Safety Recall for the Enforcer

The swivel eye on some Enforcers may not be secure and in certain conditions might unscrew. This was discovered due to an incident that occurred. This recall is to improve the security of the swivel eye and to issue new user instructions specifying that the Enforcer swiveling action is for orientation, not high speed or multiple rotations.

You can still use your Enforcer if:

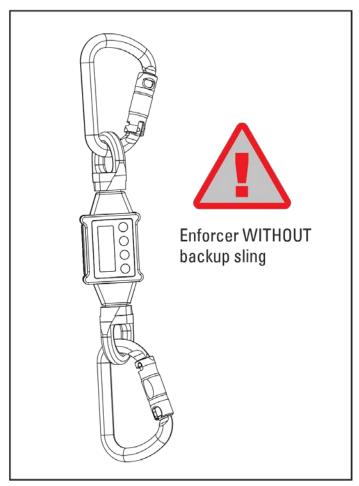
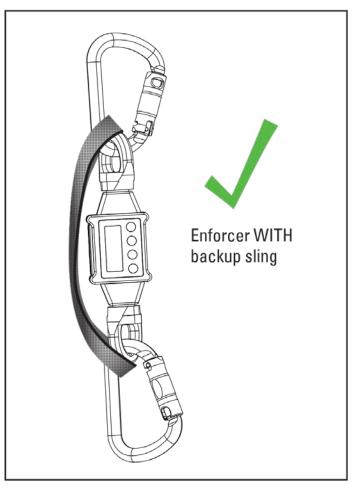
It is mandatory that you send your Enforcer in for the safety modifications as soon as possible. However, you can temporarily use it before sending it if you install a backup. Users are allowed to attach a PPE rated sling with MBS of 22 kN and a maximum of 25 cm (10 in) in length to the carabiners on either side of the Enforcer.

You must also: 1) inspect before and after each use, paying attention to making sure the swivel bolts are not loose, and 2) Do not use for high-speed or multiple rotations. Use for orientation only. 3) Do not use with steel cable. If you have any question of concerns, do not use it.
